Addendum 2 Questions CMU 2837

2	I.E. CLOSET - FRONT
A1.1	3/8" = 1'-0"

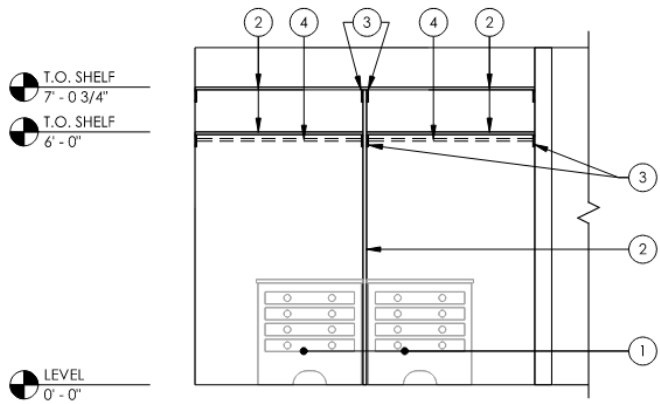
The photos included in Addendum 1 show (1) closet space roughly 4' wide with (1) framed wall, (1) MDF shelf, and (1) closet rod; sheet A1.1 on the review set of drawings shows (2) closet spaces with (1) framed wall, (1) MDF wall separating the 2 closet spaces, (2) MDF shelves, and (2) hanger rods. Please confirm how many framed walls, how many MDF walls, how many MDF shelves, and how many closet rods are needed per room.

- **See 2837 CMU Monument Hall Closets Review Set 2**
